LiDAR Quality Assessment Report

UT_Lowry-Water_2011

Pilot Data for UT_Lowry-Water_2011

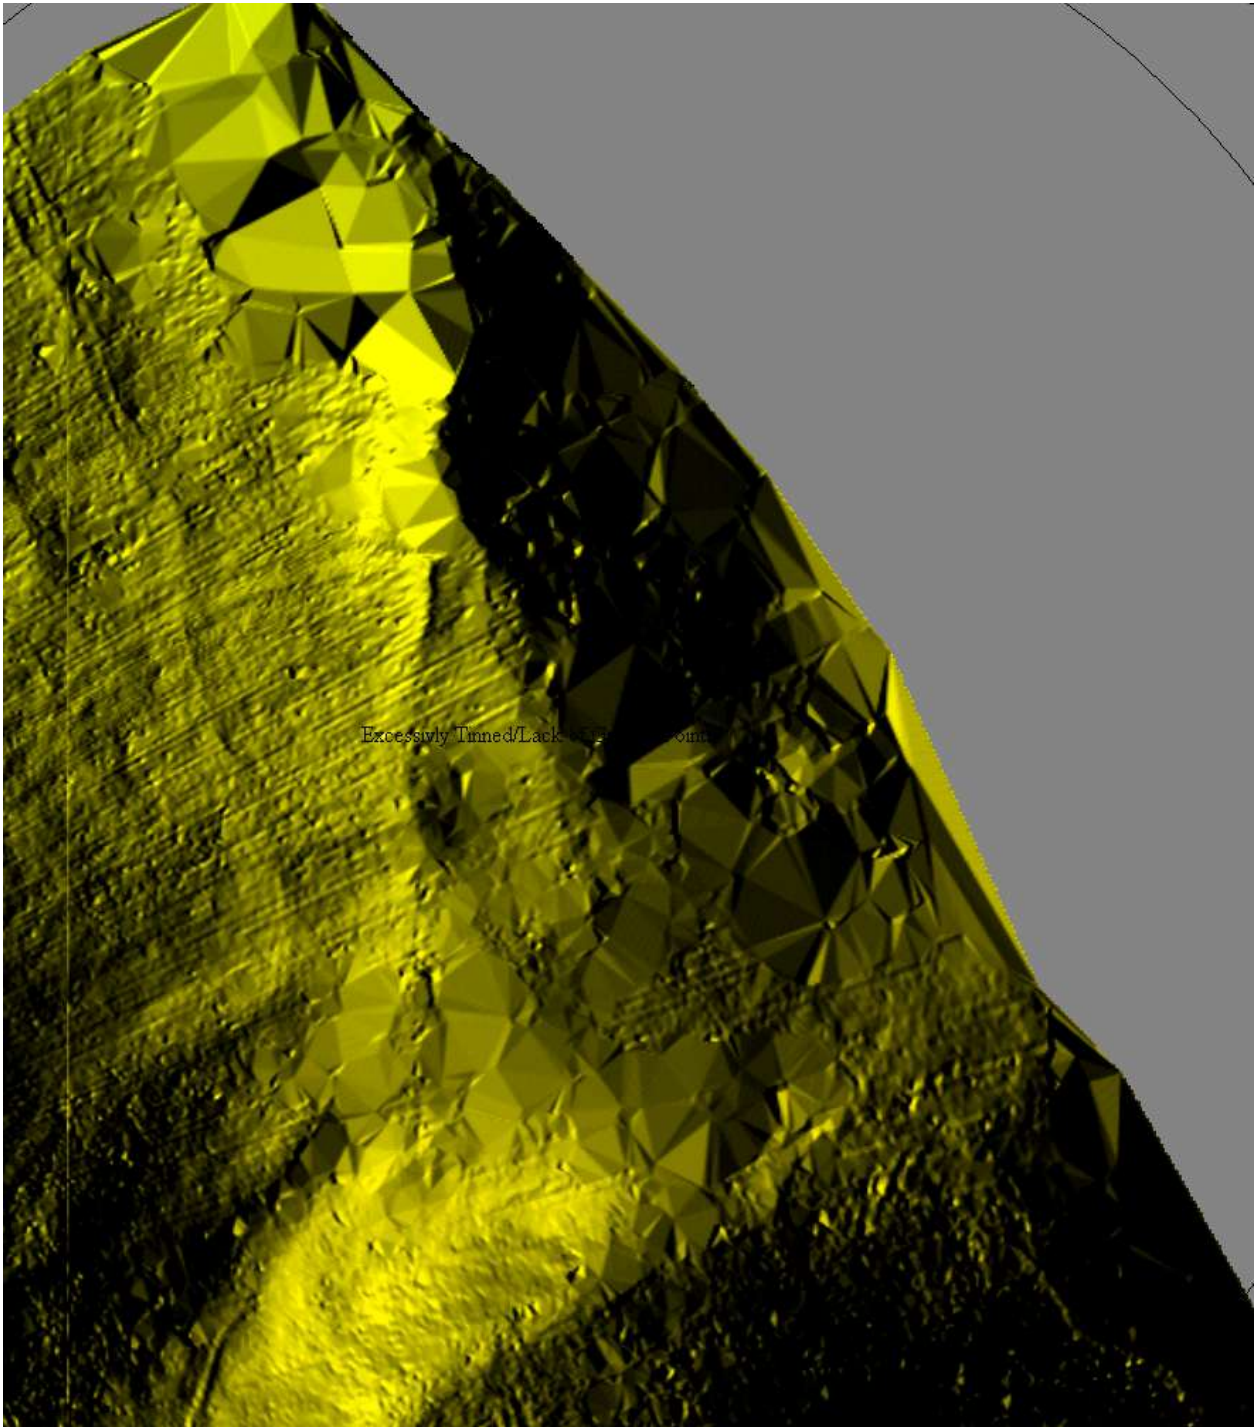
A few areas of Edge Tinning in the initial DEMs, not present in the Final to NED due to cropping of the project extent (Tile DEMs contained area outside the project extent).

Excessively Timmed/Lack of...

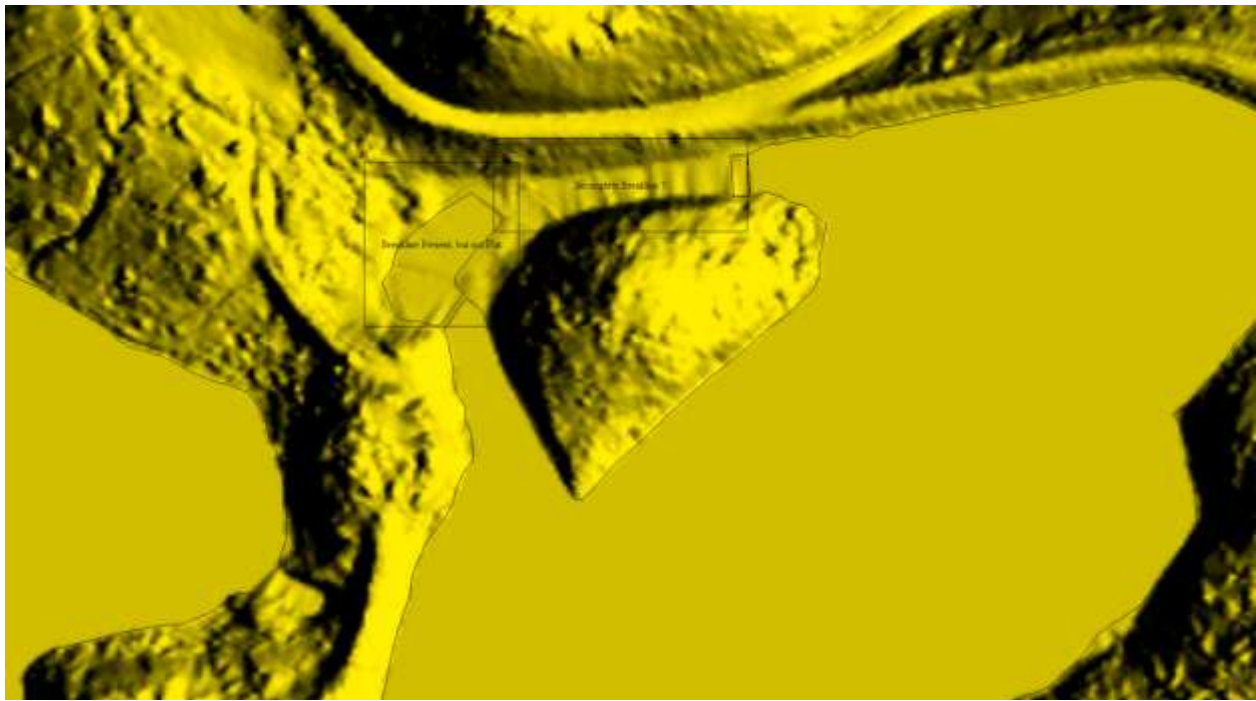
Some Heavy Tinning at edge due to dense forest canopy. This area is largely avoided in the final Mosaic.

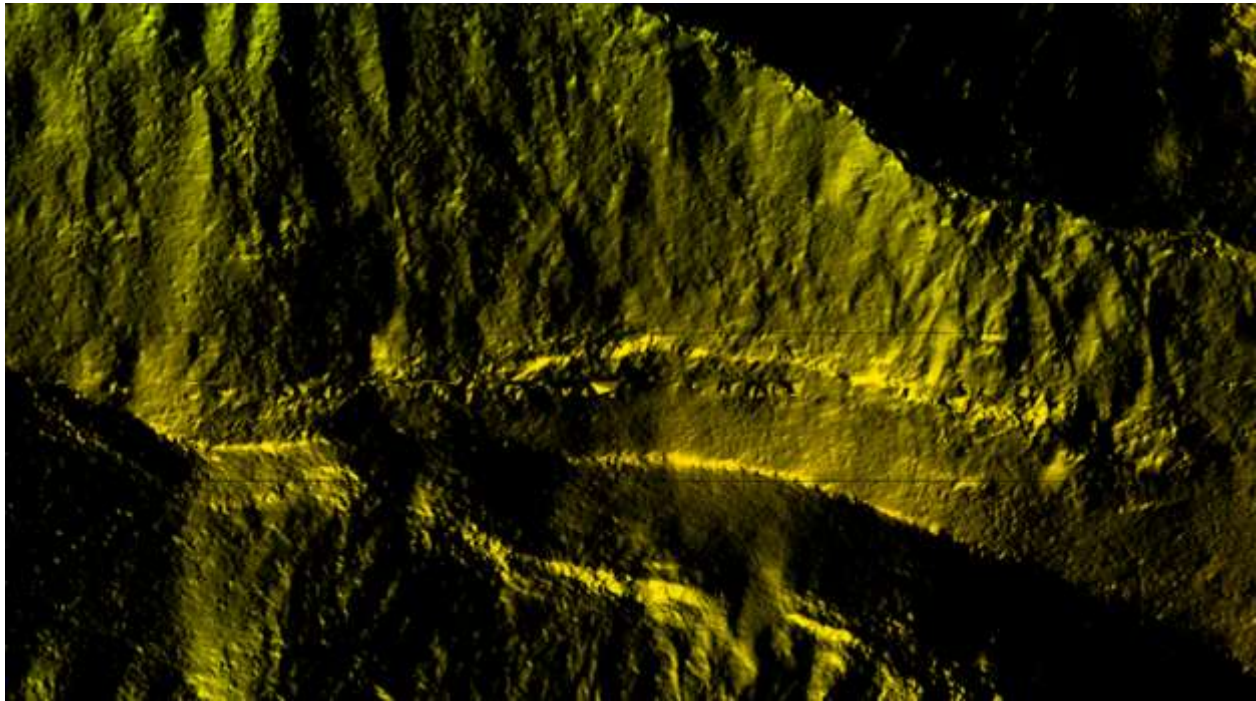
Water was flattened in the final delivery, two section of these waterbodies are questionable, but the contractor vouches for these areas.
